**Economic and Social Council**Distr.: General
20 February 2020

World Forum for Harmonization of Vehicle Regulations**Working Party on Passive Safety****Sixty-seventh session**

UN Regulation No. 100 (Electric power-train vehicles)**Proposal for the 03 series of amendments to UN Regulation
No. 100 (Electric power-train vehicles)****Submitted by the experts from Japan and the European Commission on
behalf of Task Force ***

Figure 1
Schematic to Measure Wrap-Around Distance

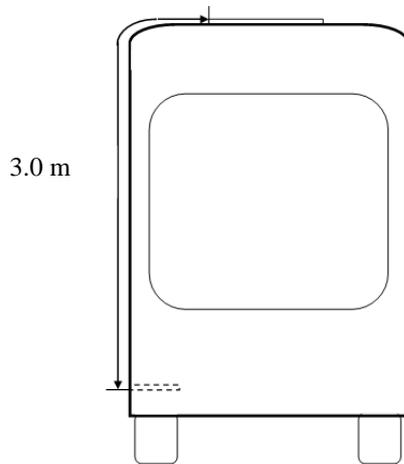
For vehicles of categories N2, N3, M2 and M3, conductive connection devices not energized except during charging of the REESS are exempted from this requirement if located on the roof of the vehicle out of reach for a person standing outside of the vehicle and, for vehicles of category M2 and M3, the minimum wrap around distance from the instep of the vehicle to the roof mounted charging devices is 3 m. In case of multiple steps due

to an elevated floor inside the vehicle, the wrap around distance is measured from the bottom most step at entry, as illustrated in Figure 1.

Example of Test Method using DC Power Supply

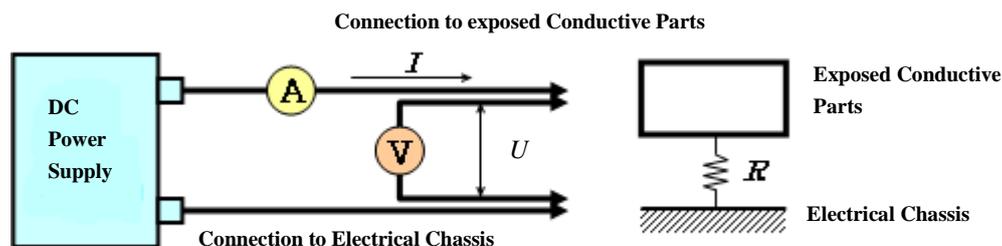
Example of the test method using DC power supply, voltmeter and ammeter is shown below.

Figure 1
Standard Nozzle for the Test

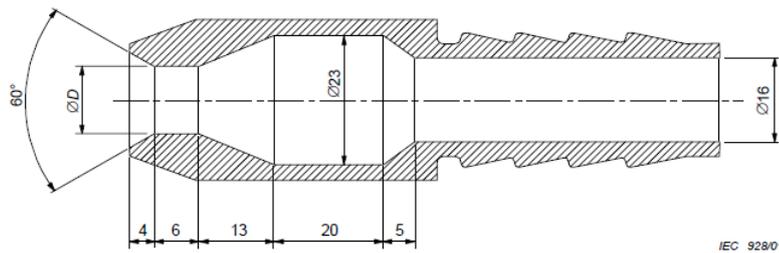
- 2.2. For electrical components, externally attached (e.g. in engine compartment), open underneath, both exposed or protected locations, the testing authority shall verify, with a view to confirming the compliance, whether the test is conducted by spraying the high-voltage component or system from all practicable directions with a stream of water from a standard test nozzle as shown in Figure 1. The following parameters are observed during the test in particular:

- (a) Nozzle internal diameter: 6.3 mm;
 - (b) Delivery rate: 11.9 – 13.2 l/min;
 - (c) Water pressure at the nozzle: approximately 30 kPa (0.3 bar);
 - (d) Test duration per m² of surface area of the tested high-voltage component or system: 1 min;

- (e) Minimum test duration: 3 min;
 - (f) Distance from nozzle to tested high-voltage component or system surface: approximately 3 m (this distance may be reduced, if necessary to ensure proper wetting when spraying upwards).

Figure 2
Splashing Test Nozzle

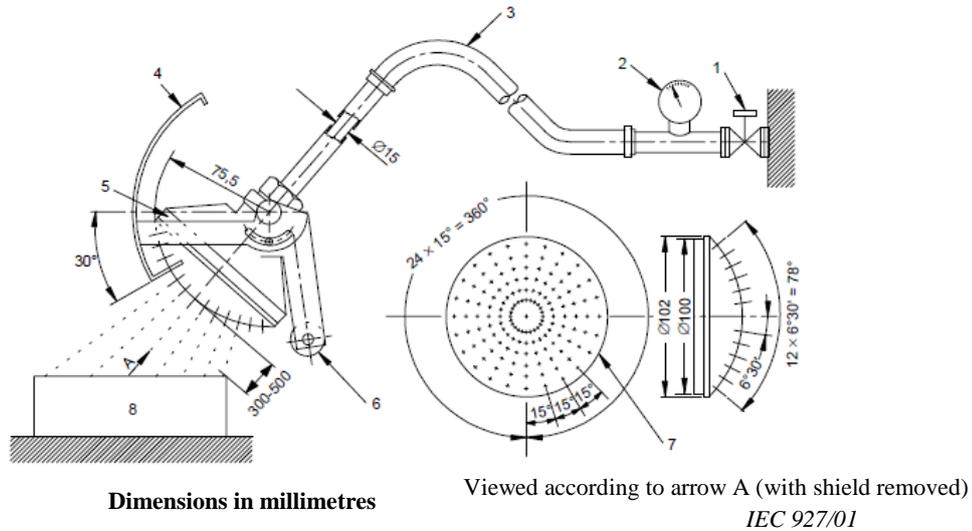
- 2.3. For electrical components, externally attached (e.g. in engine compartment), covered from underneath, the testing authority shall verify, with a view to confirming the compliance, whether:
- (a) The cover protects the component against direct spray water from underneath and is not visible;
 - (b) The test is conducted by using splashing test nozzle as shown in Figure 2;
 - (c) The moving shield is removed from the spray nozzle and the machine is sprayed from all practicable directions;
 - (d) The water pressure is adjusted to give a delivery rate of (10 ± 0.5) l/min (pressure approximately 80 kPa to 100 kPa (0.8 bar to 1.0 bar));
 - (e) The test duration is 1 min/m^2 of calculated surface area of the machine (excluding any mounting surface and cooling fin) with a minimum duration of 5 min.
